To the Members of Galway City Council

Ref. No. LA1/2024

- Ballyburke Proposed Neighbourhood Centre and Social Housing Scheme
- (a) 84 no. social residential units comprising of: (i) 25 no. one-bedroom apartments (ii) 18 no. two-bedroom apartments (iii) 16 no. two-bedroom apartments (Age Friendly Units) (iv) 2 no. two-bedroom apartments (Universal Design) (v) 10 no. three-bedroom apartments (Universal Design+) (vi) 13 no. three-bedroom terraced houses;
- (b) a new central community/neighbourhood plaza area;
- (c) local centre units;
- (d) café;
- (e) crèche facility;
- (f) renewable energy design measures for each unit and
- (g) supporting development works including (i) access roads (ii) grouped parking spaces; (iii) landscaping; (iv) surface water attenuation tank; (v) temporary construction signage; (vi) estate signage; and (vii) all associated site works at Ballyburke, Galway

Architects Report addressing submissions received in respect of proposed Neighbourhood
Centre and Social Housing Scheme at Ballyburke, Galway City.

Above: Building Height Study showing proposed storey heights.

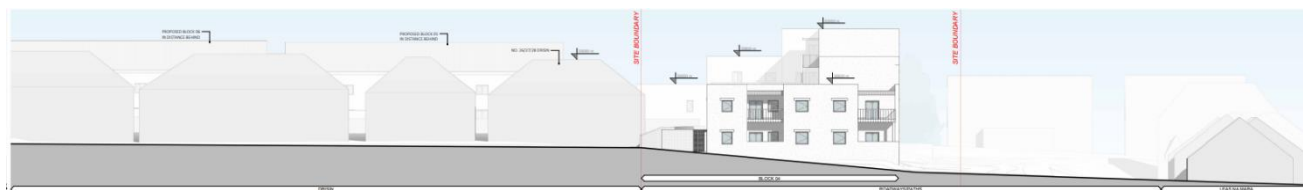
With regards specifically to the proposed 6 level building, as this is mentioned in numerous submissions, this height only relates to part of one building, Block No. 2, it is noted from the Site Layout plan submitted the highest portion of the building would be positioned between 45.70 m and 49.30 m from the northern boundary, in addition this section of the building would be in line with the proposed and existing access road to Drisin. In this case the distance to the northern boundary, its position at a lower level, its alignment with proposed and existing roadways, would not create undue overshadowing of existing developments on lands to the north. While the setting and context of this building, which is to be adjacent to a public square/space and would be a landmark building for the wider development and is considered to be in keeping with the overall development of these lands, aid in achieving a sustainable density of development and as previously outlined would be in keeping with the relevant policies and guidelines for such developments. This issue is also addressed in the response to submissions.

The massing and scale of the design is considered sensitive to the existing built fabric to the north, stepping in height as it moves away from Maoilín and Drisín and bringing focus to the proposed local centre and new community area. A building height study has been carried out to show the percentage of storeys proposed. The scheme is predominately 2 storeys (31.5%) as shown in yellow in diagrams, with these located adjacent to the neighbouring northern estates. The 3 storey elements (pink) account for 19.5% of the scheme and are divided among all blocks. The 4 storey sections (green) make up 38.5% of the overall building heights and are located at prime areas in the scheme; at the entrance to the Ballyburke road and adjoining the local centre and plaza. The 6-storey block (orange) accounts for only 10.5% of the overall scheme and is designed to create a focal point at the new neighbourhood centre and is located at the furthest possible point from the neighbouring estates to the North.

Regular meetings were held with the Planning Department throughout the design of the proposed scheme. It was highlighted that the building heights in Block 02 could be taller to help define the community aspect of the design. No issues were raised in relation to the building heights and no requests were made for Tall Building Statements or Impact Assessments, further to the contents of the Design Statement.

Above: 2D shadow analysis extract from accompanying report of private amenity space of neighbouring dwellings

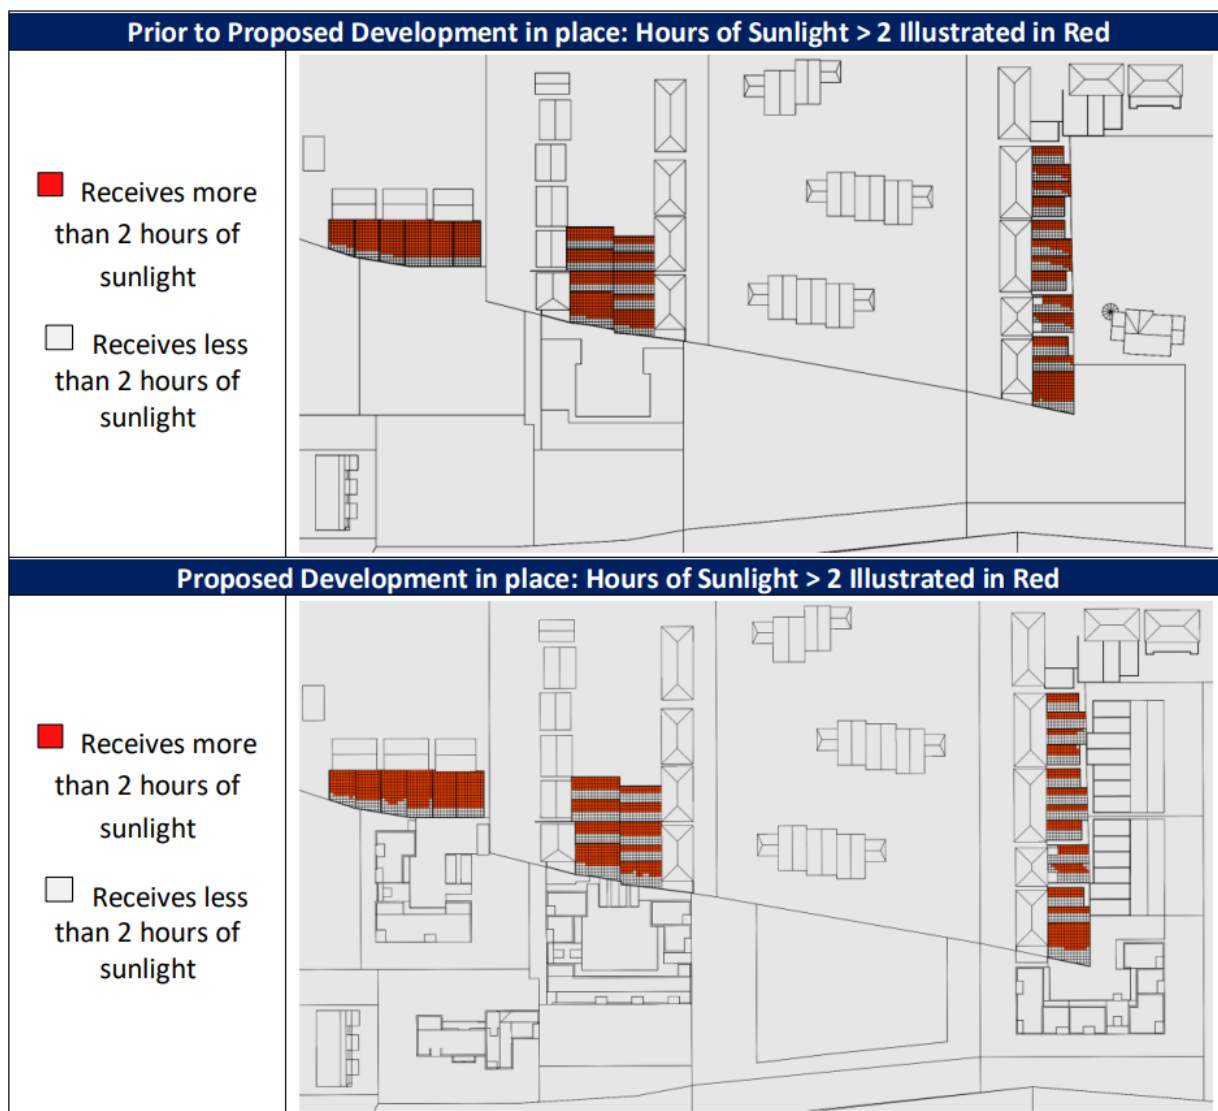
The extracted image below from the accompanying overshadowing study also identifies the private amenity spaces to be studied numbered 1 – 28 and impacts of overshadowing on these spaces in detail.

The requirement for a space to be deemed adequately sunlit is outlined in the accompanying report as “As outlined in Section 3.3.17 of the BRE Guide (3rd Edition), for a space to appear adequately sunlit throughout the year, at least half of the garden or amenity space should receive at least 2 hours of sunlight on March 21st.” The following extracted image outlines the hours of sunlight received on the 21st of March prior to the development and then also following the developments construction.
